**TOWN OF MOUNTAIN VILLAGE  
REGULAR DESIGN REVIEW BOARD MEETING  
AGENDA**

**THURSDAY SEPTEMBER 3, 2020 10:00 AM**

**TO:** Mountain Village Design Review Board  
**FROM:** John Miller, Senior Planner  
**FOR:** Design Review Board Public Hearing; September 3, 2020  
**DATE:** July 23, 2020, *Updated August 21, 2020*  
**RE:** Staff Memo – Initial Architecture and Site Review (IASR) Lot 630

**2 ADDRESS MONUMENT - FRONT**  
SCALE: 1" = 1'-0"

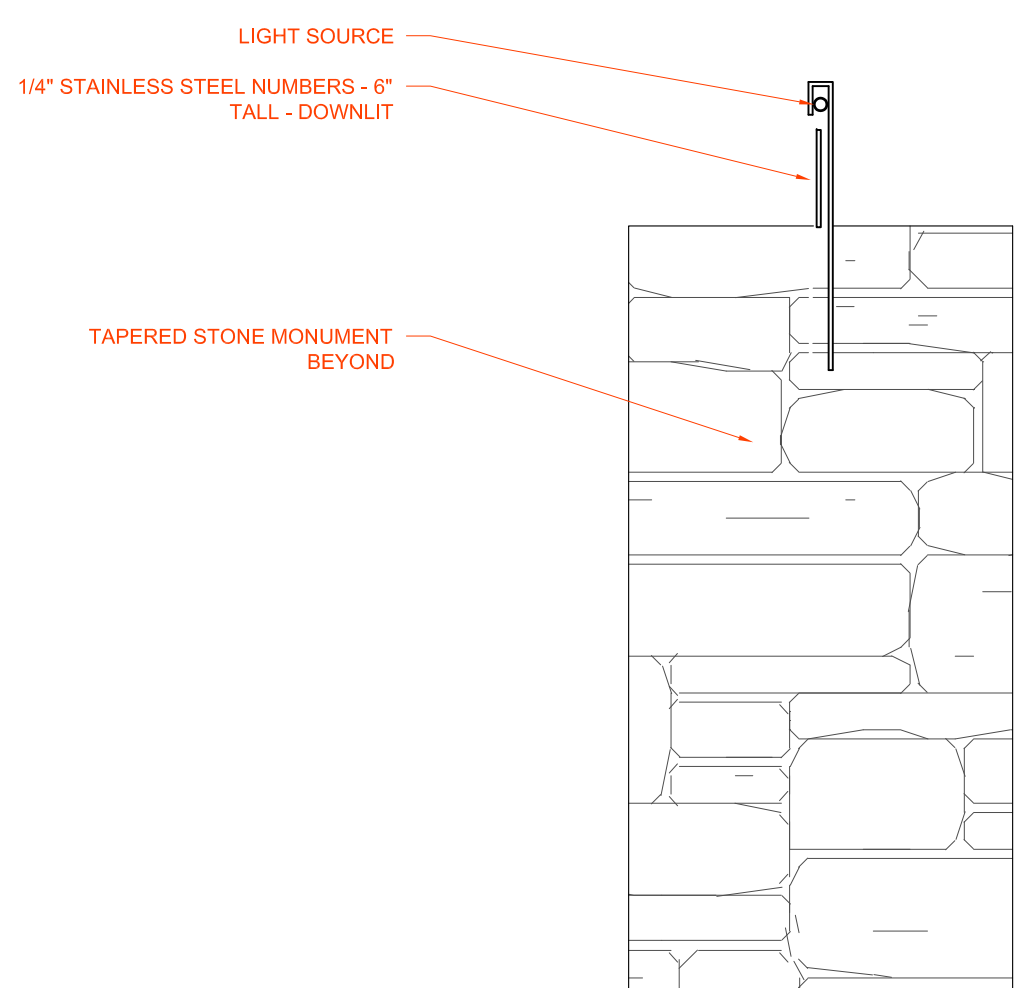
*Staff: The address monument has been revised since the July hearing so that the lighting source is downlit per the request of staff. Prior to FAR, the applicant shall include the lighting source as part of the lighting plan to demonstrate it meets requirements of the CDC. Additionally, per Fire Department comment, the base of the numbering shall be at least 54" from the adjacent grade and the numbers must be coated with a reflective covering in case of power outages.*

- 1) Prior to submittal for a Final Architectural Review, the applicant shall revise the proposed address monument so that the Numbering is a minimum of 54" above adjacent grade.
